**METROPOLITAN GOVERNMENT OF NASHVILLE AND DAVIDSON COUNTY**

**STAFF RECOMMENDATION**  
**1702 Fatherland Street**  
**May 21, 2014**

**Application:** New construction - addition  
**District:** Lockeland Springs-East End Neighborhood Conservation Zoning Overlay  
**Council District:** 06  
**Map and Parcel Number:** 08314019800  
**Applicant:** Craig Kennedy, Architect  
**Project Lead:** Sean Alexander, sean.alexander@nashville.gov

**SCALISE RESIDENCE**

**H1.1**

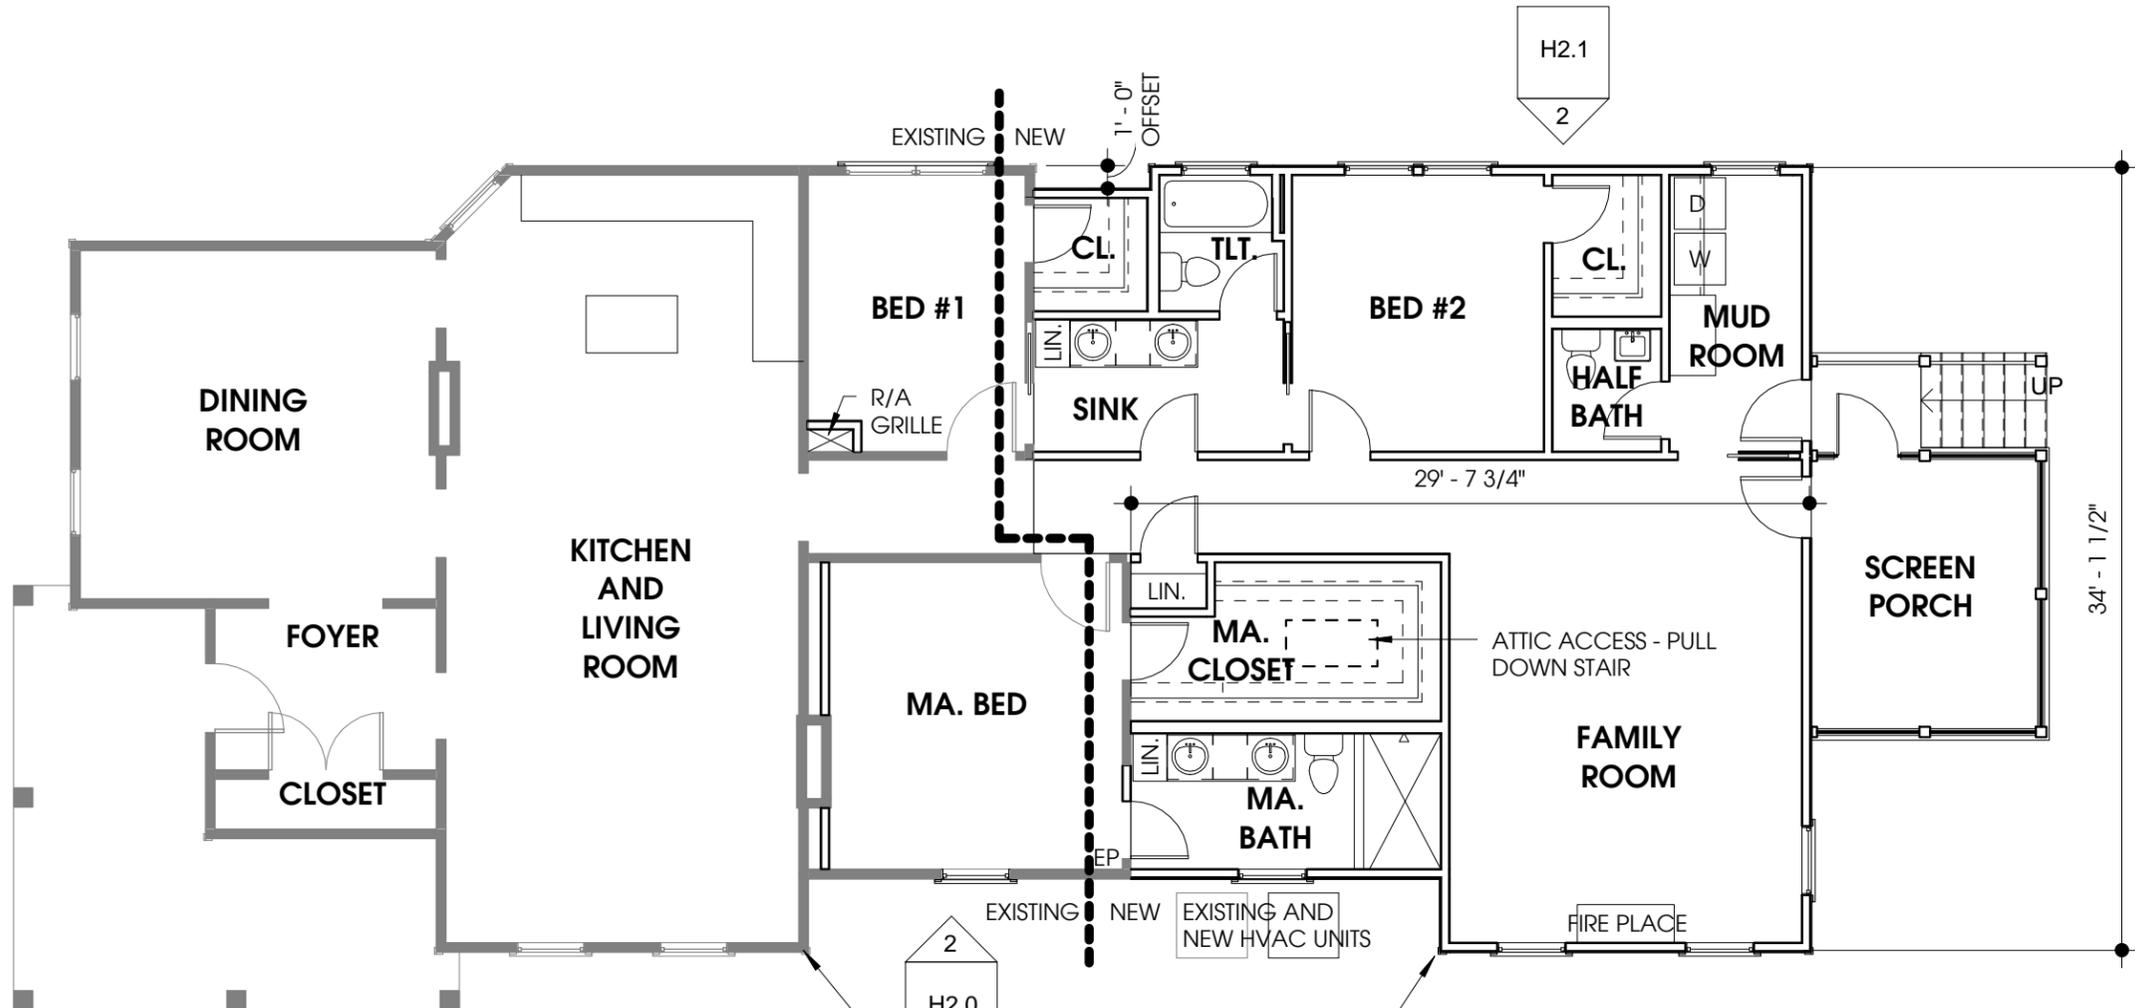
**Analysis and Findings:** The applicant is proposing to partially demolish an existing rear addition and construct a new rear addition. The original structure will not be altered.

A non-historic portion of the building at the rear that sits in from the sides of the historic house and is therefore only minimally visible will be demolished. This portion is not significant to the historic character of the house.

The project meets section III.B.2 for appropriate demolition and does not meet section III.B.1 for inappropriate demolition.

The new addition will set in from the side of the original house with a one foot (1') by five foot (5') alcove on the left, and will align with the wall of an earlier addition that sits in three feet (3') from the right side of the historic house. With the addition, the depth of the house will be extended from fifty-six feet (56') to seventy-six feet from front to back, with a screened porch adding another ten feet (10') at the rear. The roof of the addition will tie into the rear slope of the existing roof, five feet (5') below the peak of the pyramidal roof and one foot (1') below the ridges of the hip and gable projections. The eaves and foundation of the addition will match the heights of the corresponding features of the historic house.

**ELEVATIONS**

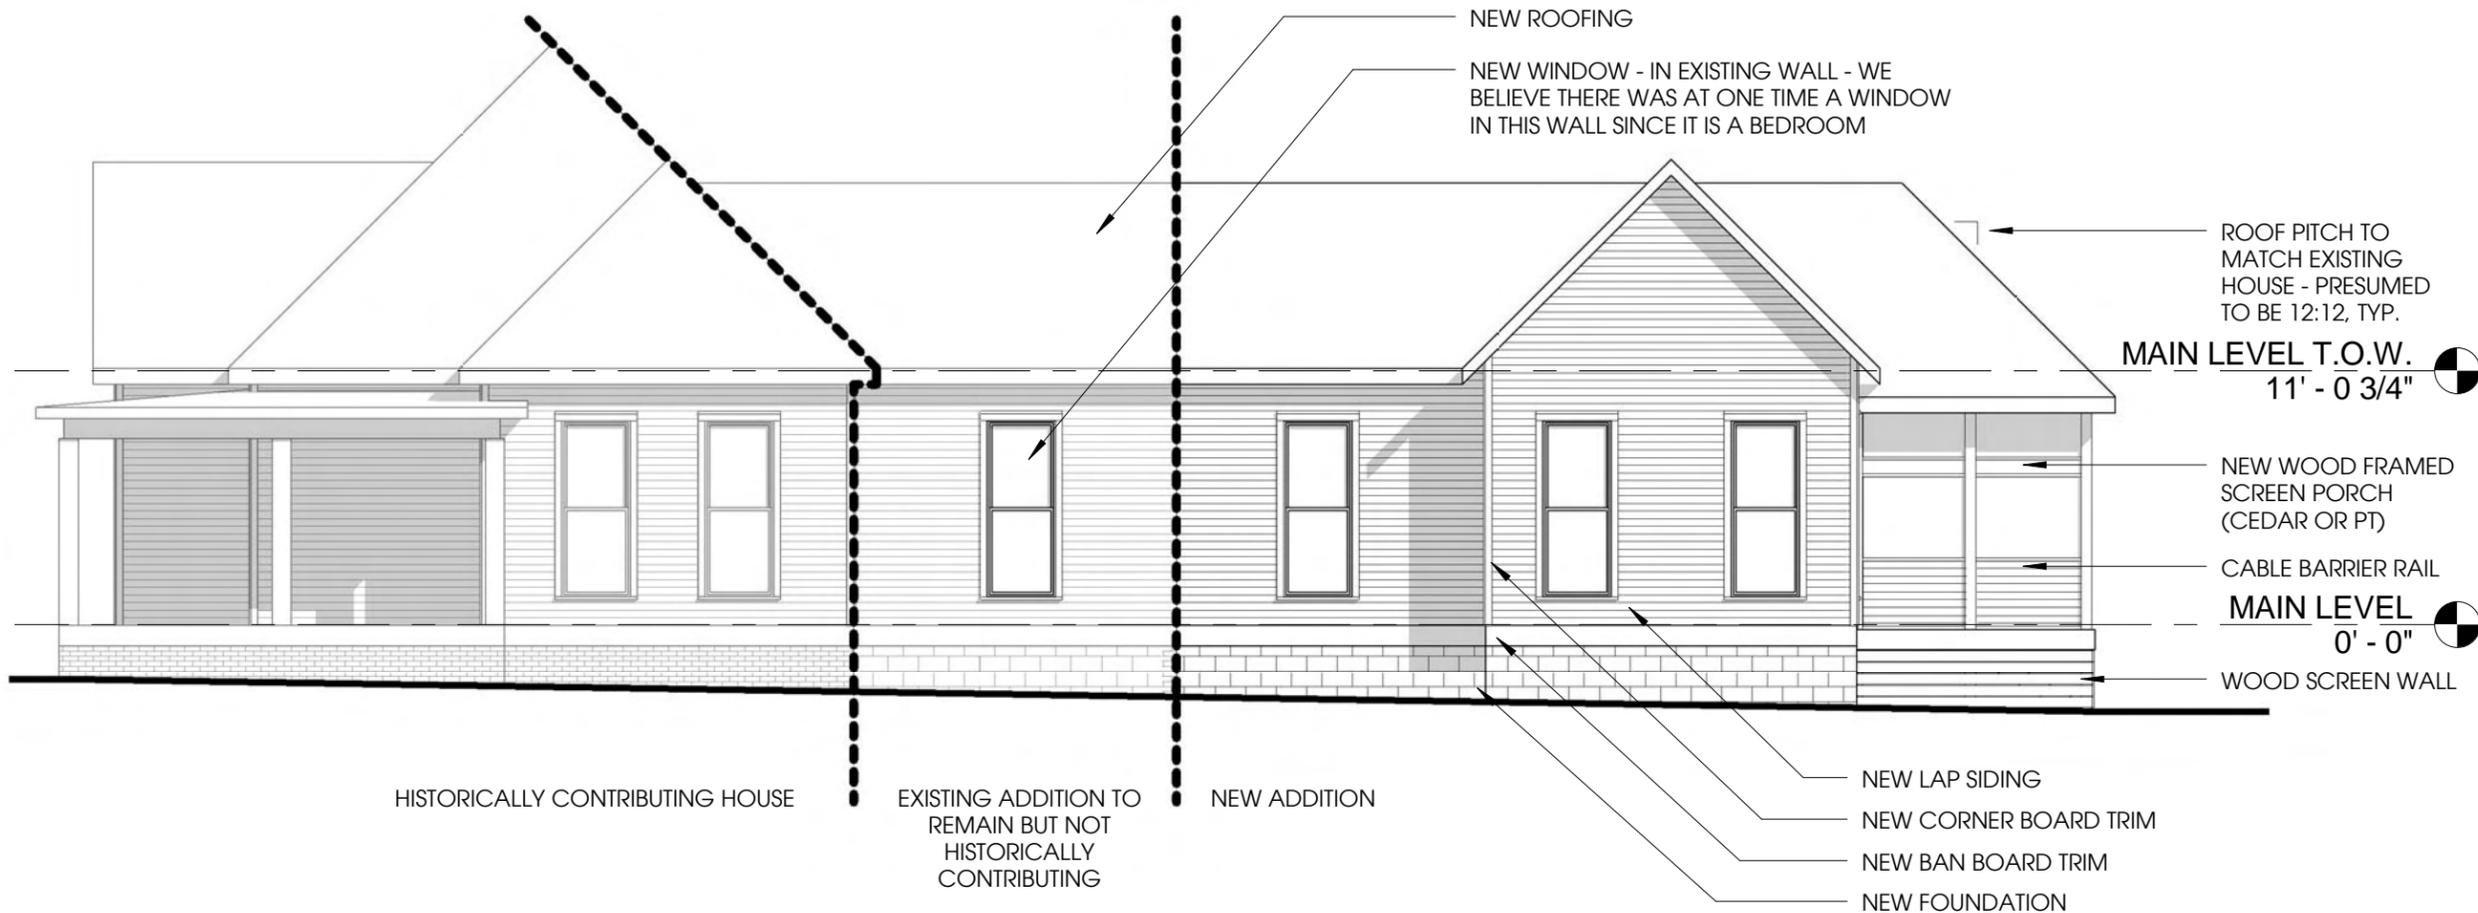
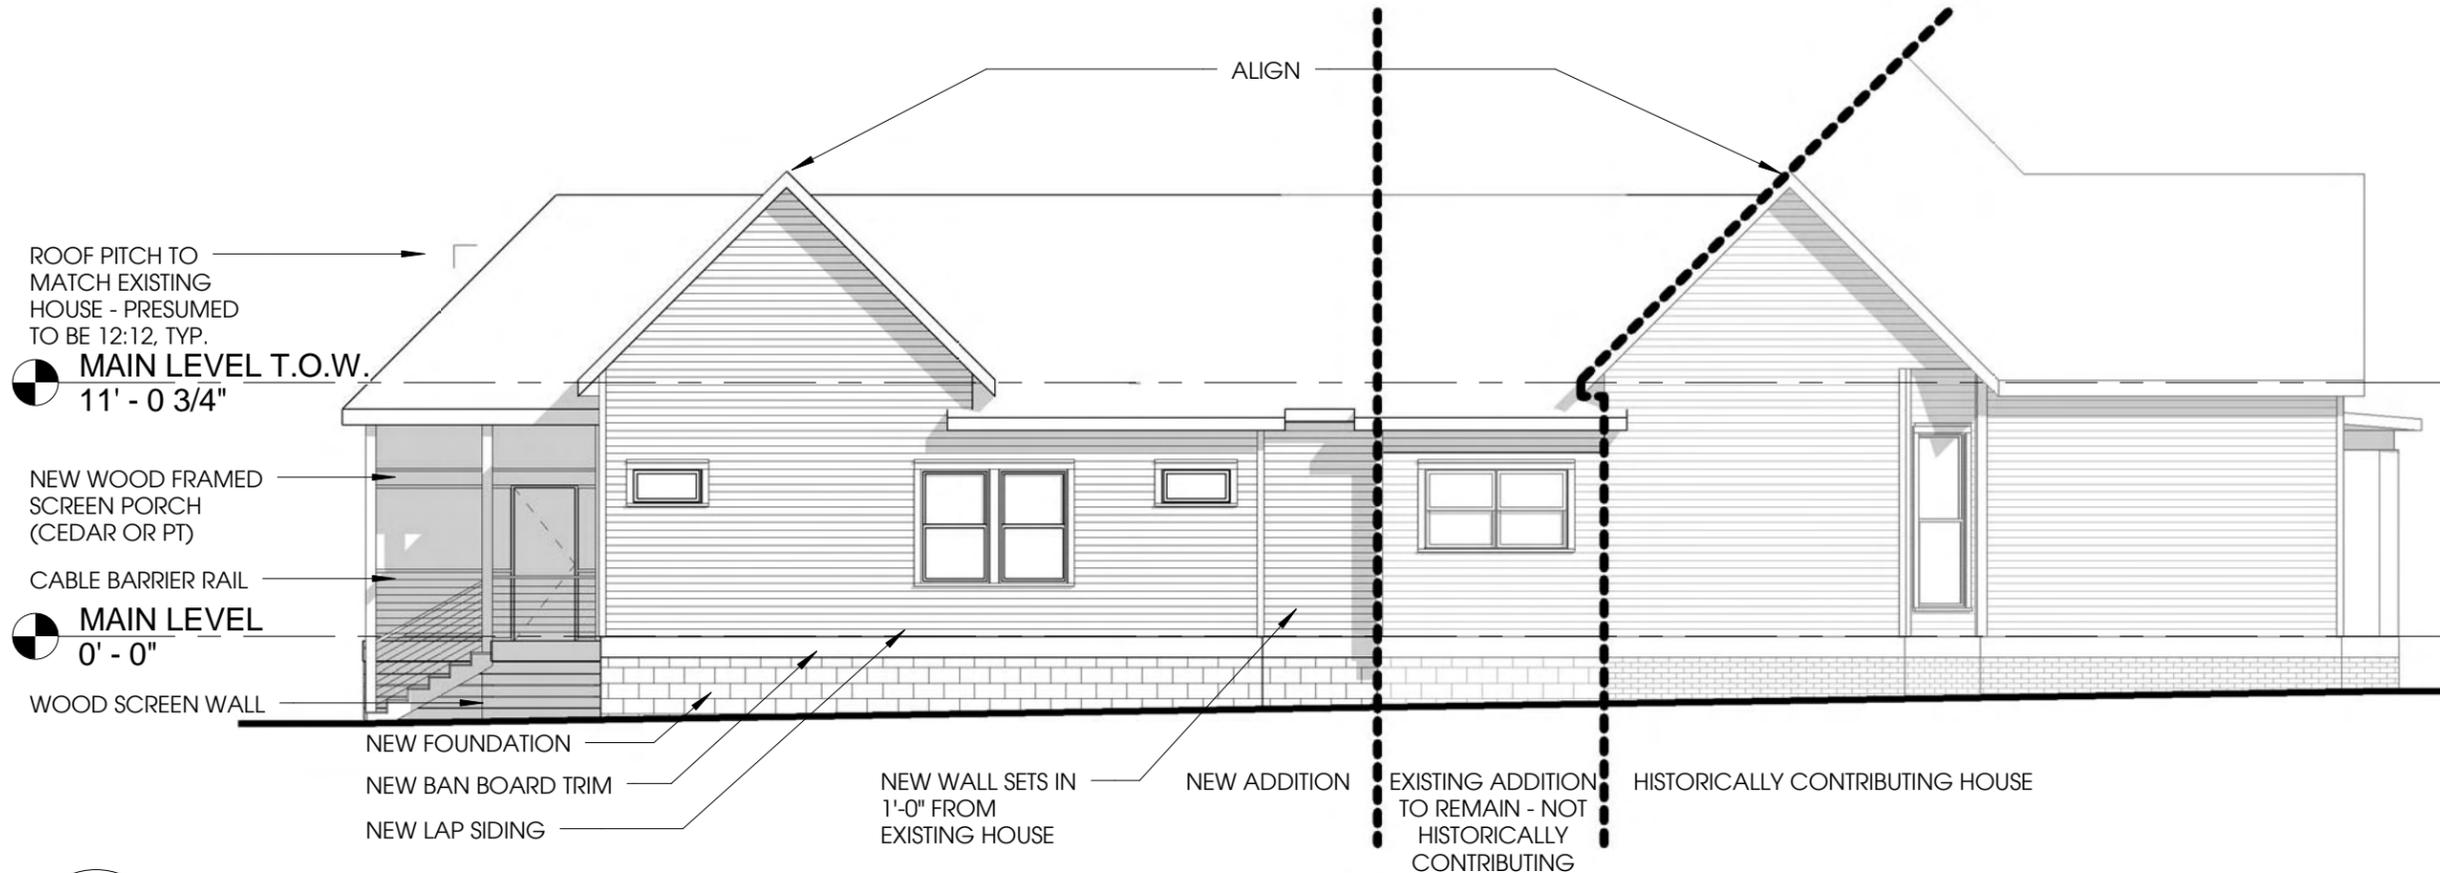
No major changes to the historic house's materials were indicated on the drawings. The addition will primarily be clad in smooth face cement fiberboard with a four inch (4") reveal. The trim will also be cement-fiberboard. The foundation will be concrete block with a parge-coat finish, and the roof will be architectural fiberglass shingles in a color to match the existing roof. The materials for the new windows and doors will be wood, aluminum-clad, or fiberglass, and staff asks to approve the final selection prior to purchase and installation. The rear porch will be wood with a cable railing and screening, and will be inset sufficiently from the sides of the house so as not to be visible. With the staff's final approval of the windows and doors, staff finds that the known materials meet guideline II.B.4

The addition will have a side-oriented gable at the rear, with a "saddle" tying into it from the existing roof. This connector roof will have a 12:12 pitch on the right side and a 4.5:12 pitch on the left, but the asymmetry will be obscured behind the original pyramidal roof and the gable projection on the left. The side-gabled roof of the addition will match the forms and pitch of the original roof. Staff finds that the project meets section II.B.5 of the design guidelines.

Proportion and Rhythm of Openings: A window will be added to a blank wall on the portion of the earlier addition that is remaining, but no other changes to the window and door openings on the existing house were indicated on the plans. The windows on the proposed addition are all generally twice as tall as they are wide, thereby meeting the historic proportions of openings. There are no new large expanses of wall space without a window or door opening. Staff finds the project's proportion and rhythm of openings to meet Section II.B.7.

Appurtenances & Utilities: No changes to the site's appurtenances were indicated on the drawings. The location of the HVAC and other utilities was also not noted. Staff asks that the HVAC be located on the rear façade, or on a side façade beyond the midpoint of the house. The project meets section II.B.9.

Staff recommends approval of the partial demolition and new construction, with conditions that the windows and the location of the HVAC are approved by Staff.
